Access Compliance Report

Public Rights-of-Way

(Pedestrian Signals)

Intersection ID: N/A	Main Street:	Cross Street: N/A	Location: N/A
ADA ID: FE56A277584F	Signal Type: Two Push Buttons-APS	Overall Compliance: No	Severity Score: BTN 1:N/A BTN 2: N/A No BTN: N/A
Codes/Mitigation Info/Possible Solution		Field Measurements/Component Compliance

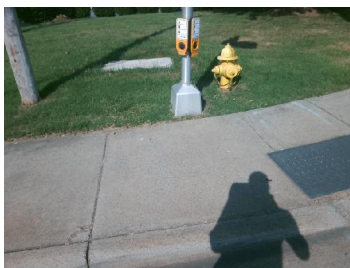
Surveyor Notes: TEXT HT 5/16

PROW/ADA: R410.6, R209.1, TMUTCD 4e.08,
R404.2, R404.3, R406.2,

Possible Solutions: Remove & Replace
Replace APS Button With New APS Button.
Remove and Replace Clear Space.
